February 27, 2024

HISTORICAL ANALYSIS AND DESIGN REVIEW:

Property Address: 55 S Riverview Street
Dublin, Ohio 43016

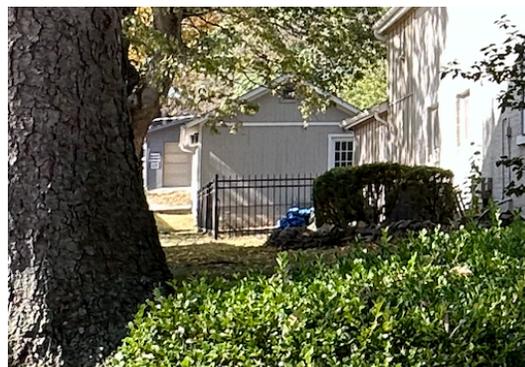
The renderings below illustrate the massiveness of the proposed garage addition in comparison to the original structure as well as the complicated and competing massing and roof lines on the west elevation and the addition decorative brackets on the heavy stone hyphen. The east elevation of the garage should have windows as well to add scale and detail.

- Revise the roof lines and massing of the garage and hyphen to lessen the competing forms and revisit the conceptual design to create a more simplified and elegant solution.
- Study the materiality of the hyphen to lighten the connection to the attached garage. The use of stone and transom windows is heavy and not in keeping with the character and with the concept of a hyphen to connect structures.

Views of existing Garage:

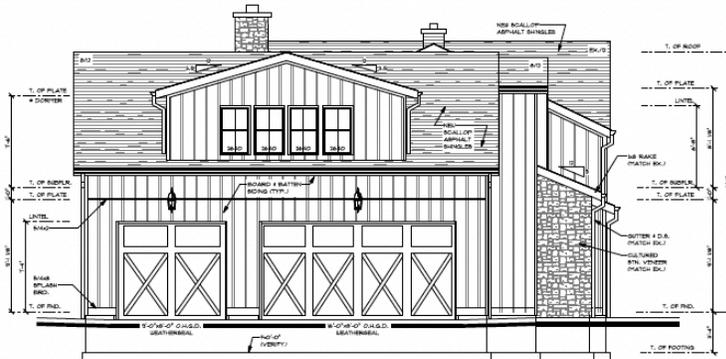
Below are views of the existing garage. There is no significant impact to the street and the structure is not very visible from the sides or front of the property, only from S Blacksmith Lane.

This structure, while currently classified as Contributing, could easily be replaced with another garage, attached or detached, and maintain all characteristics that currently categorize it as Contributing. For this reason I would consider it ~~Non-Contributing~~. I would, however, consider that this portion of the site is the appropriate location for a garage and would support this request for the designation to be changed to ~~Non-Contributing~~ providing it is done with the approval of a new garage.

- The request for reclassification of the garage from Contributing to Non-Contributing is appropriate in the context of the proposed addition. The design of the new, attached garage however, should be simplified and better proportioned in keeping with the original conceptual design..
